ETHOS URBAN

Shell Cove Boat Harbour and Marina (DA 95/133) – Outer Harbour Modification Response to Submissions (RtS)

Table 1 Response to Submissions

Figure 1 Pedestrian pathway between BMF and Boat Lift

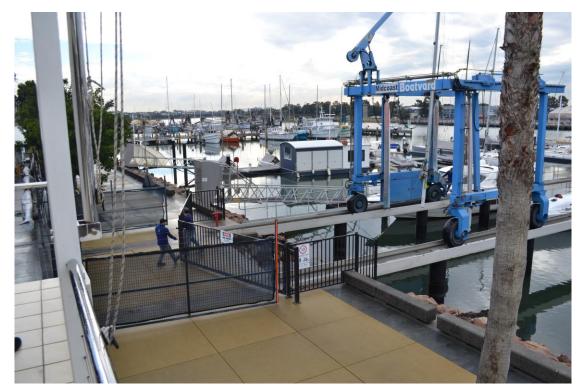
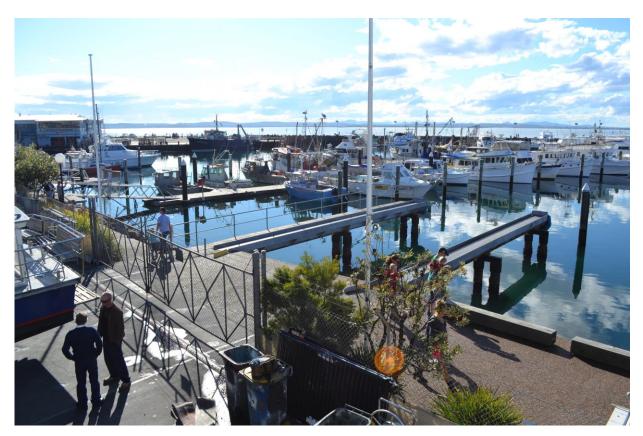
The purpose of this modification is to relocate and consolidate the outer harbour structures with the adjacent BMF, thereby minimising the conflict between the operation of the Marina and the harbour foreshore and pedestrian links.
Demonstrate that public access to the harbour foreshore will be maintained.	Public access around the harbour foreshore will be maintained with systems put in place to limit the impact of the BMF and Boat Lift on pedestrian access surrounding the harbour foreshore.
	Appendix A illustrates how the interface of the public open space, between the BMF and the outer harbour structures, may occur during boat movement. As discussed below, principles for the operation of this facility will be agreed upon to minimise the impact on pedestrians.
Minimise the potential for vehicle, bicycle and pedestrian conflicts.	The design and operation of the BMF and Boat Lift will seek to minimise potential conflicts with pedestrians along the harbour foreshore. This will be assessed as part of the future BMF development application.

Nevertheless, the following principles will be incorporated into the design of this facility in order to minimise the potential for conflict between pedestrians and the BMF: Limit to the hours of operation; Opening of gates between each boat movement (i.e. no more than one boat in a row); The BMF manager to monitor the movement of boats; and Wayfinding signage for the public to move around the BMF and foreshore. We note that the proponent is in the process of preparing a design for the BMF and adjacent open space. The principles for the operation of
	the BMF will be fully addressed as part of this future DA and be incorporated in the Marina Plan of Management.

Figure 4 Boat Harbour / Marina Plan

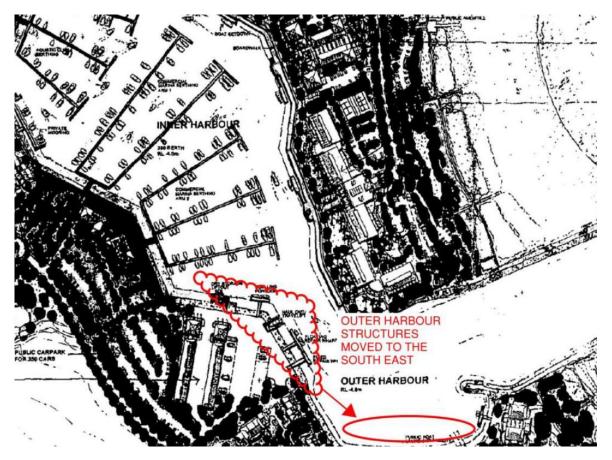
Issue	Response
Additionally, an overall plan comparing the existing approved layout to that proposed should be submitted.	This plan was provided within the original Section 75W Modification Report. Refer to Figure 4 in Appendix B.
The Precinct A UDGs attached to the modification application are not the signed endorsed version. Further, as an environmental assessment requirement of the concept approval it is inappropriate for UDGs to form part of any approval.	The Precinct A UDGs form supporting documentation to MOD 8. They are not intended to form part of the approval.
